**ADDENDUM #2**  
**GFWTP 1916 HEAD HOUSE UPGRADES**  
**TD&H Job Number 23-232**  
**September 9, 2025**

**REPLACE the following sheets with the attached**

GREAT FALLS WATER TREATMENT PLANT O.F. 1332.7  
GREAT FALLS, MT  
1916 HEAD HOUSE UPGRADES  
LEVEL 1 DEMOLITION PLAN

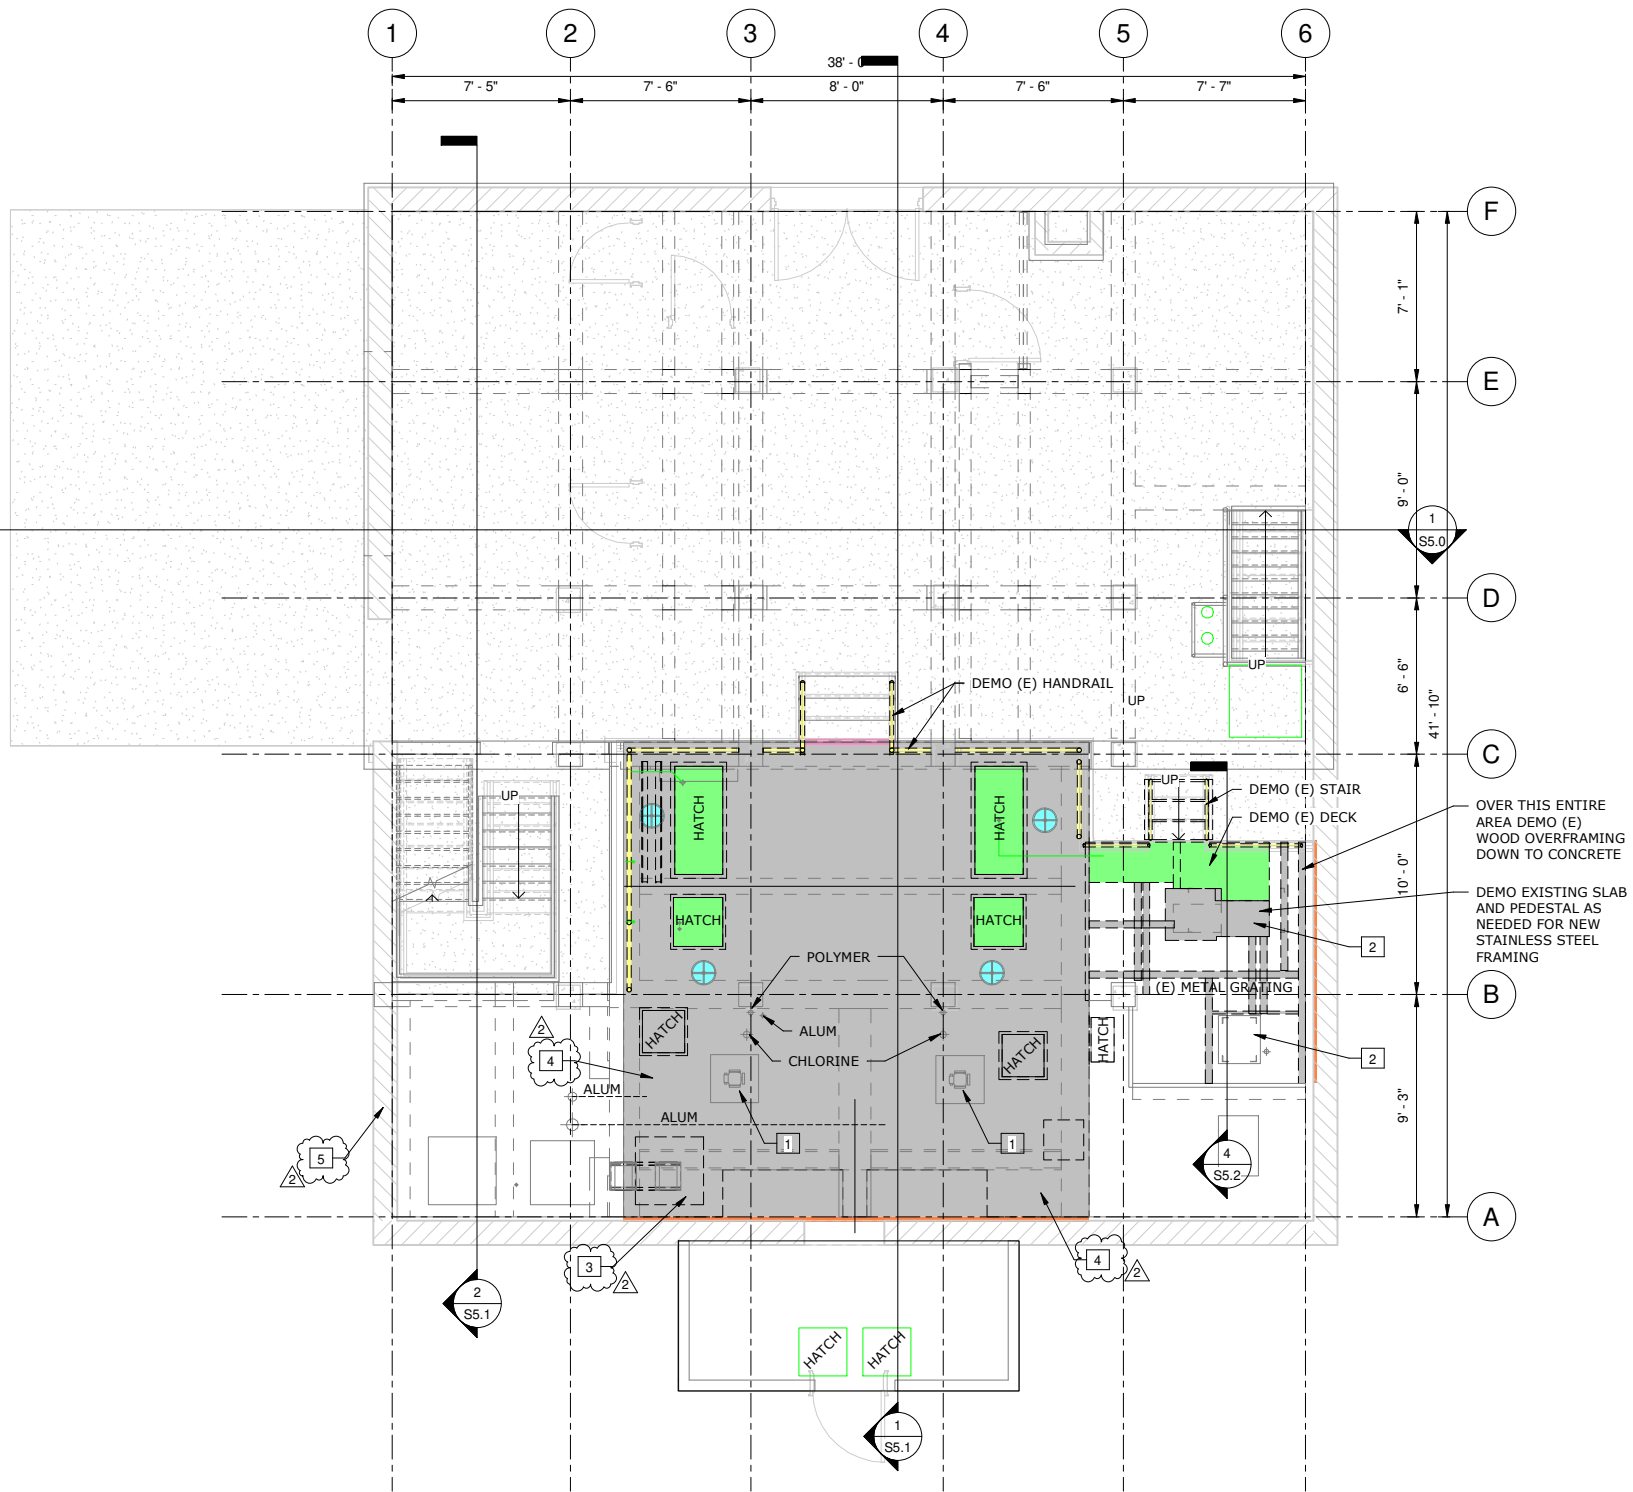
**Sheets S2.1 – ADDED** flag notes to clarify Rapid Mix demolition.

- 1 RAPID MIXER - TEMPORARILY REMOVE AND INSTALL AFTER CONSTRUCTION TO MEET MANUFACTURER REQUIREMENTS
- 2 CARBON EQUIPMENT - TEMPORARILY REMOVE AND INSTALL AFTER CONSTRUCTION TO MEET MANUFACTURER REQUIREMENTS
- 3 PIPE EMBEDDED IN CONCRETE PEDESTAL. DURING DEMO, CUT AND CAP PIPE BELOW THE SLAB.
- 4 AFTER DRAINING THE RAPID MIX TANKS FOR DEMO, PLUG THE HOLE IN THE BOTTOM OF THE TANK FLOOR AND USE EXTERNAL PUMPS TO MANAGE ANY ADDITIONAL WATER INFLOW.
- 5 INSTALL TEMPORARY DOOR IN EXISTING WINDOW, SEE 011000 SPEC FOR TEMP DOOR REQUIREMENTS.

GREAT FALLS WATER TREATMENT PLANT O.F. 1332.7  
GREAT FALLS, MT  
1916 HEAD HOUSE UPGRADES  
ENLARGED LEVEL 1 REPAIR PLAN - OPERATING FLOOR

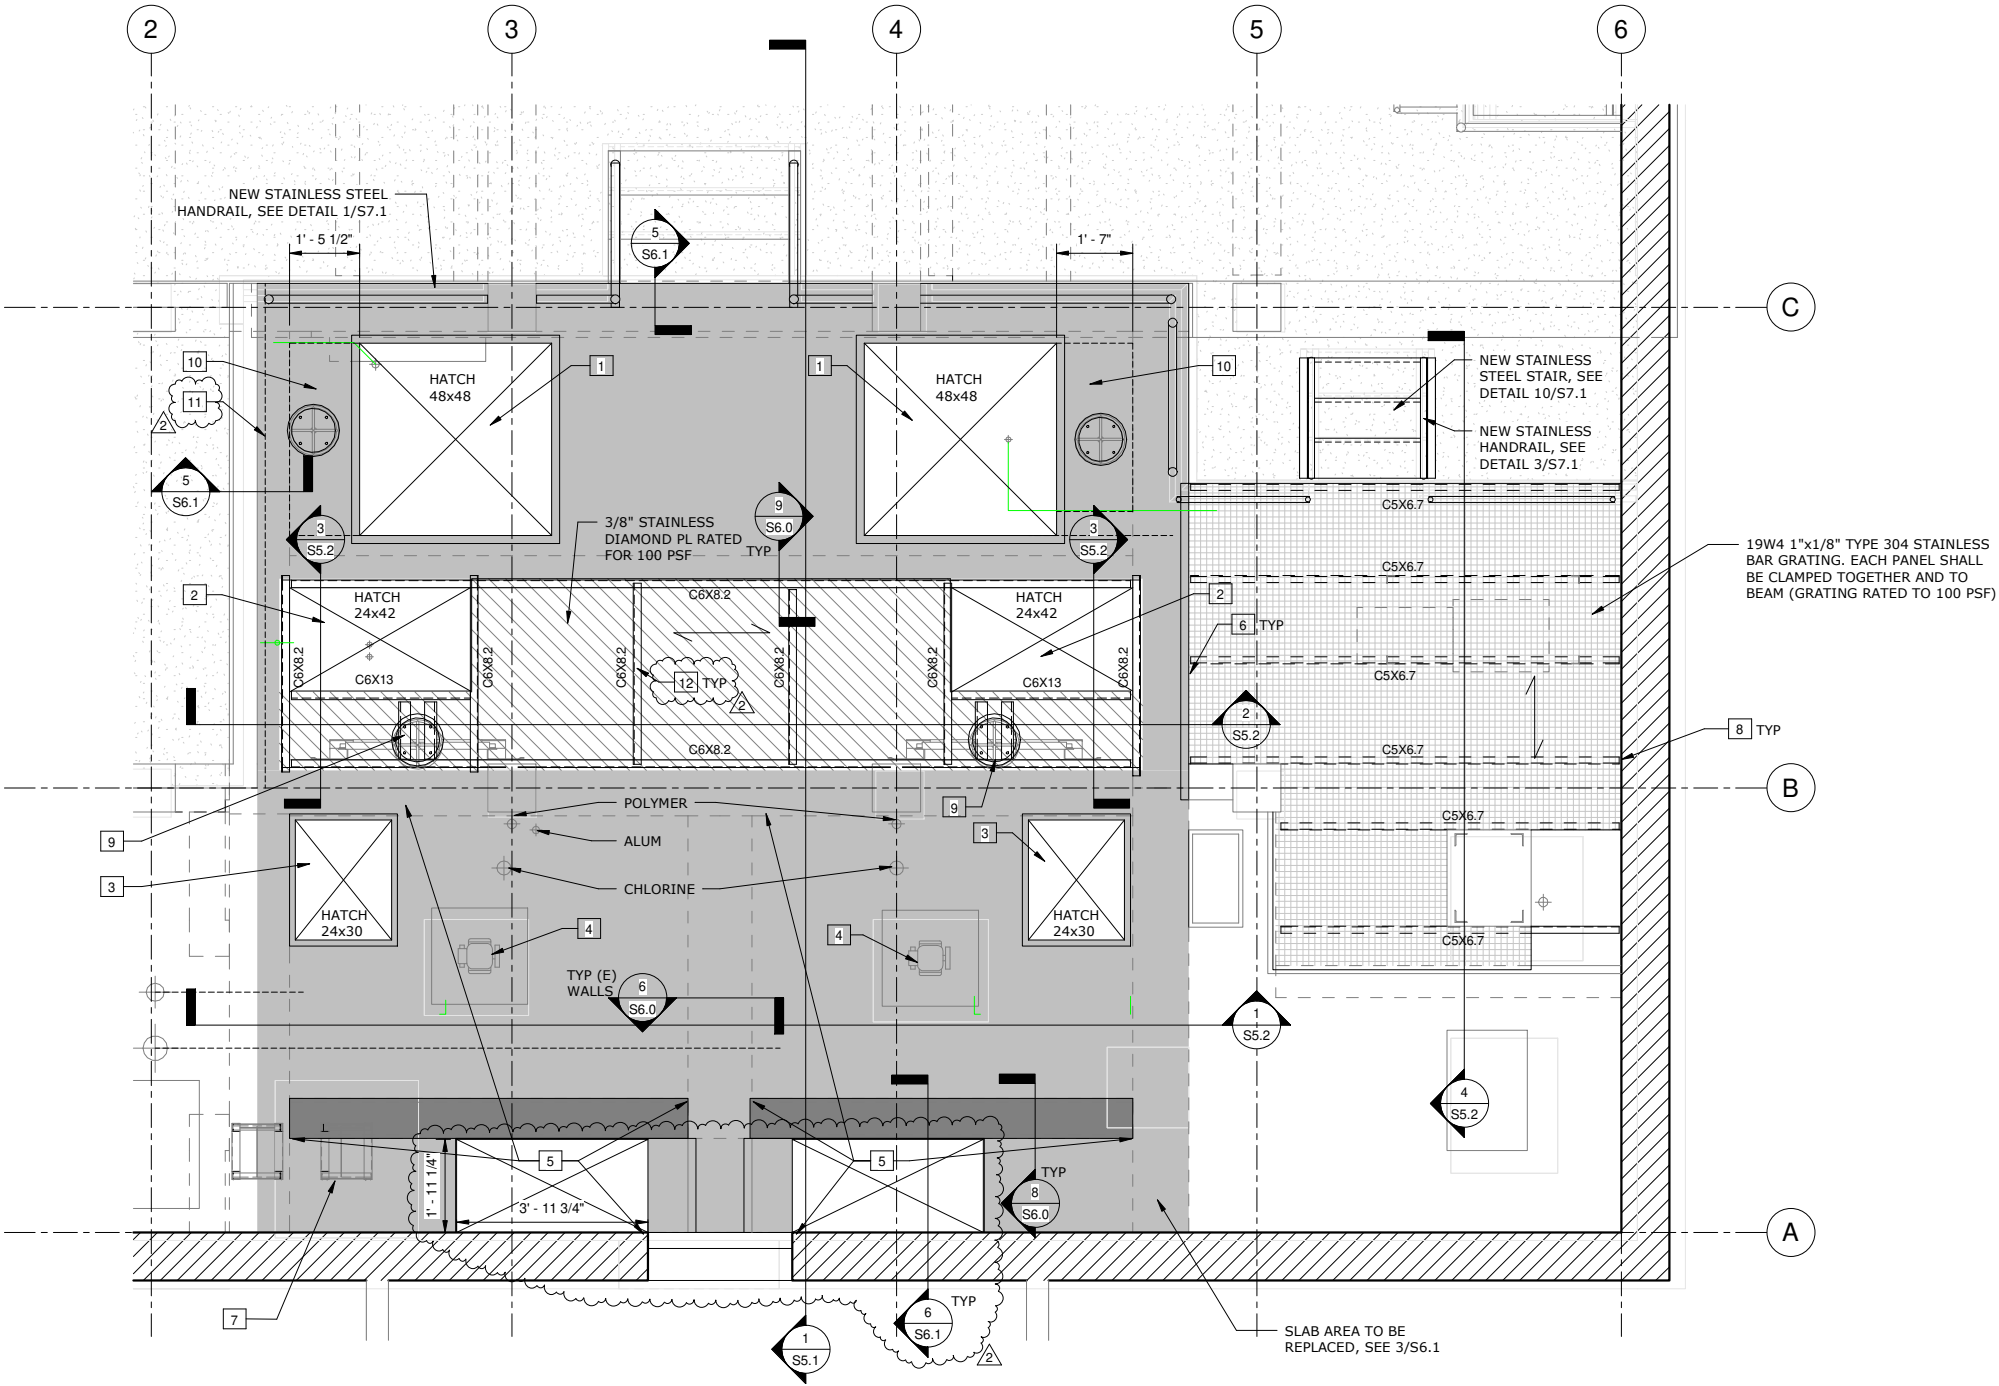
**Sheet S3.2 – EDITED** flag notes 1, 2 & 3 with correct hatch model.

– ADDED flag notes 11 & 12.

- 1 NEW HALLIDAY S2G STAINLESS STEEL HATCH, SEE DETAIL 12/S6.0
- 2 NEW HALLIDAY S1G STAINLESS STEEL HATCH, SEE DETAIL 5/S7.1
- 3 NEW HALLIDAY S1G STAINLESS STEEL HATCH, SEE DETAIL 11/S6.0
- 4 REATTACH RAPID MIXER MOTOR AND BLADE ACCORDING TO MANUFACTURER REQUIREMENTS
- 5 PATCH ALL RAPID MIX INSIDE TANK WALLS PER NOTES ON SHEET S1.1
- 6 CONNECTION AT CONCRETE WALL PER DETAIL 6/S7.1
- 7 SUPPORT EXISTING MECHANICAL EQUIPMENT WITH NEW STEEL FRAME, SEE DETAIL 1/S7.2
- 8 CONNECTION AT BRICK WALL PER DETAIL 9/S7.1
- 9 GATE SUPPORT, SEE DETAIL 4/S7.1
- 10 GATE SUPPORT SPANNING ENTIRE WIDTH OF CHAMBER, SEE DETAIL 2/S6.1
- 11 SAWCUT EXISTING CONCRETE SLAB 2" FROM EXISTING STAIRWELL STUD WALL.
- 12 FLOOR PLATE ATTACHMENT PER DETAIL 7/S6.1

11 SINGLE DOOR HATCH (CONCRETE SUPPORT)  
1 1/2" = 1'-0"

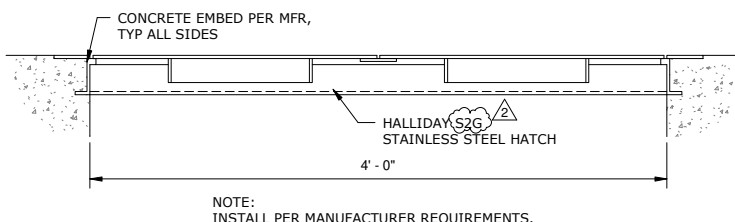
**Det. 11/S6.0 – DELETE** reference to Halliday F1G and REPLACE with Halliday S1G.

12 DOUBLE DOOR HATCH (CONCRETE SUPPORT)  
1 1/2" = 1'-0"

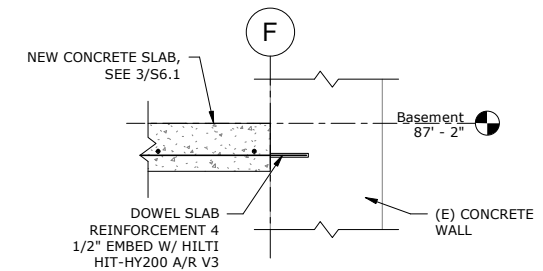
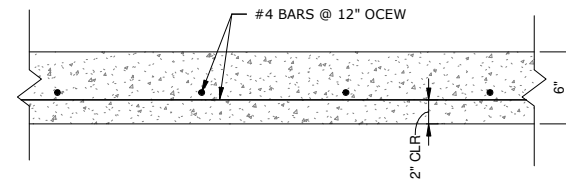
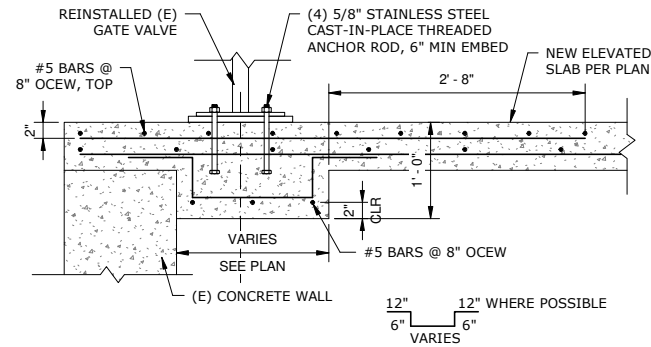
**Det. 12/S6.0 – DELETE** reference to Halliday F2G and REPLACE with Halliday S2G.

**FLOOR PLATE ATTACHMENT AT RECEIVING CHAMBER**

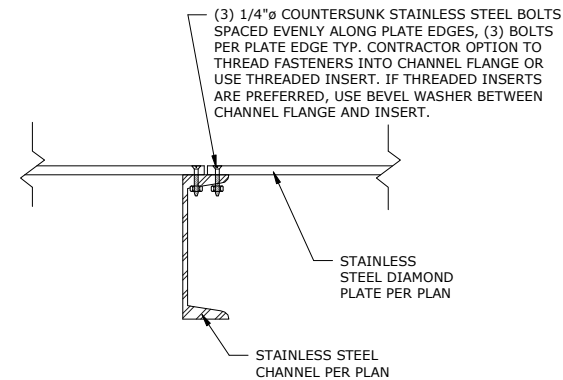
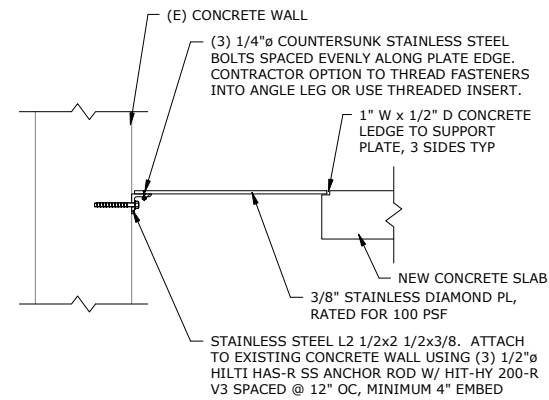
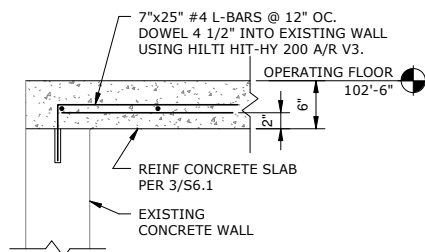
**Sheet S6.1 – ADDED** details 6 & 7.

## SINGLE DOOR HATCH (STEEL SUPPORT)

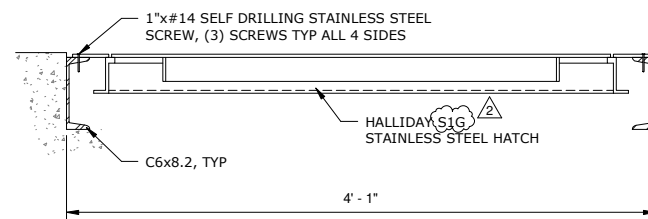
**Det. 5/S7.1 – DELETE** reference to Halliday F1G and REPLACE with Halliday S1G
